UNITED STATES ENVIRONMENTAL
PROTECTION AGENCY
REGION IX
75 Hawthorne Street
San Francisco, CA 94105

STATE OF HAWAII
DEPARTMENT OF HEALTH
P. O. BOX 3378
HONOLULU, HI 96801-3378

Re: Approval to revise schedule for deliverables 6.3- Investigation and Remediation of Releases Report and 7.1.3. - Groundwater Flow Model Report of the Red Hill Administrative Order on Consent ("AOC") Statement of Work ("SOW") and Comments on Interim Environmental Reports

ATTACHMENT 2

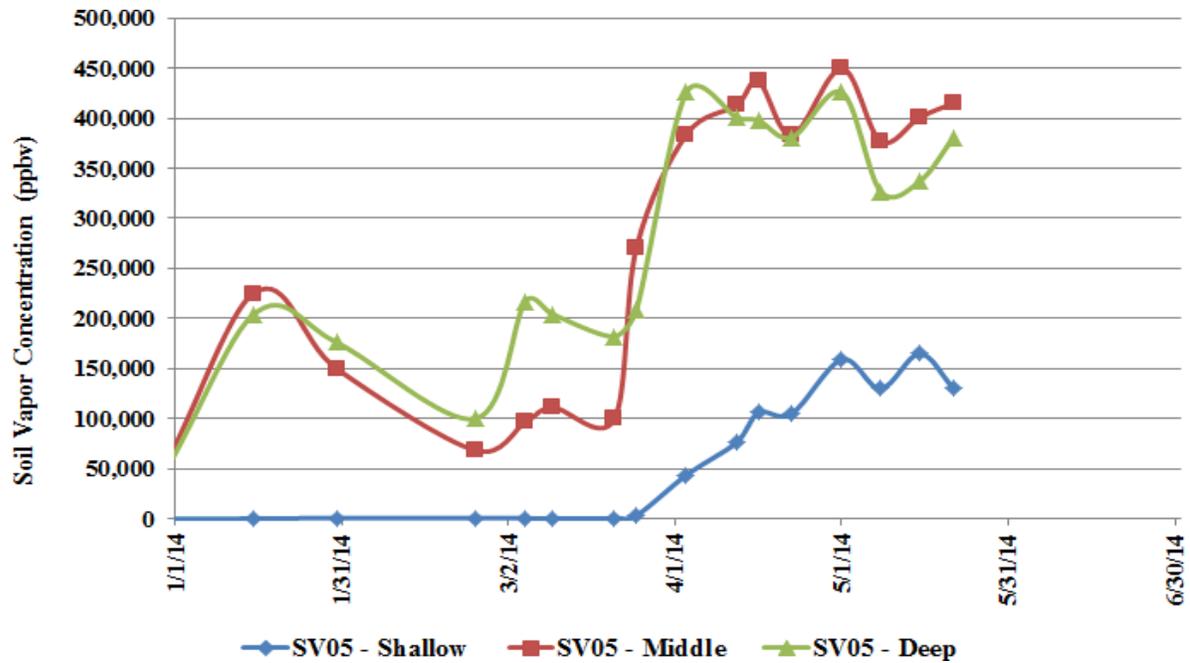
The in situ vapor probe response around Tank 5 in the timeframe following the 2014 release can be interpreted as indicating that the primary vapor migration may have been to the northwest side of that tank and not in the direction of RHMW02 (see Figure 10.2 below). Actual LNAPL transport outcomes beneath Tank 5 in 2014 below the vapor probes is unknown; the conservative assumption based on this limited data is that transport was potentially to the northwest and is not represented with any certainty by the spatially limited monitoring well array.

1. Strike and Dip

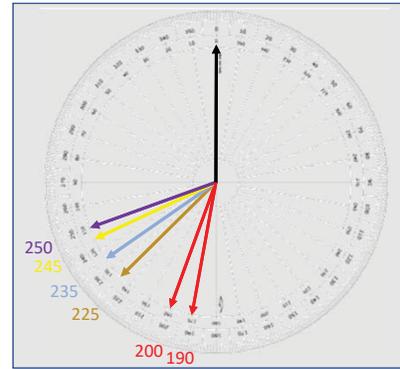
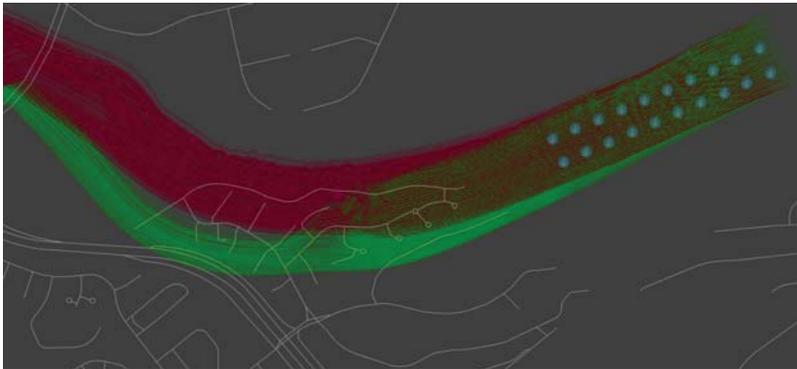
- Rudimentary tests - paths sensitive to assumed direction, magnitude
- Thorough testing or sensitivity analysis requires grid-realignment or full conductance tensor

2. Saprolite Extents

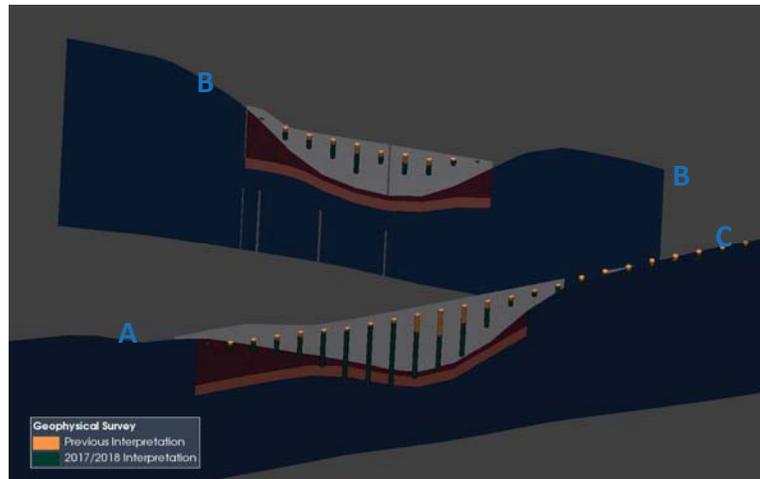
- Valley alluvium thickness
- Systematic pattern of modeled saprolite depth
- Early termination of longitudinal extents of saprolite
- Layer elevations based on prior interpretations may require revision to accurately represent conditions

3. Cap Rock, Tuffs, Sediments

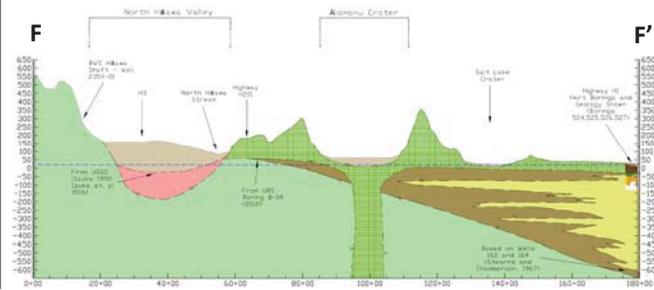
- Model appears to lack the confining nature of older alluvium.
- Expect bulk hydraulic conductivity of the caprock to be $\ll 1,000$ ft/d

6. Calibration – Heads, Gradients

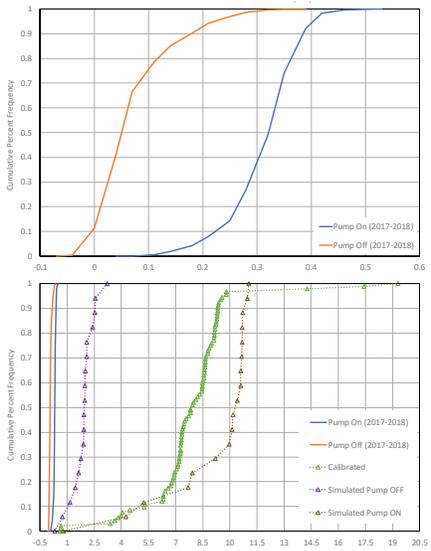
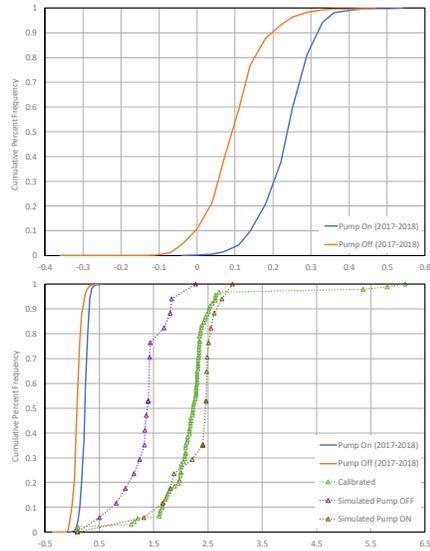
- Historic manual data infrequent, irregular
- Synoptic data improve CSM
 - Time-weighting
- Absolute head vs. gradients
- Systematic difference

Chemistry shows indication of a poorly mixed system

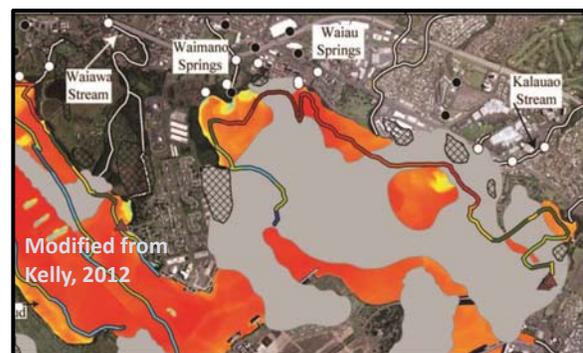
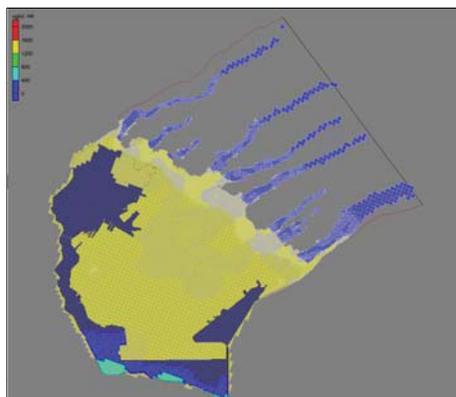
- Chloride conc. vary from ~40- >1000 mg/L
- Southeast very different from northwest
- Northwest chlorides still highly variable
- A large flux of groundwater down the Red Hill ridge should show better mixing
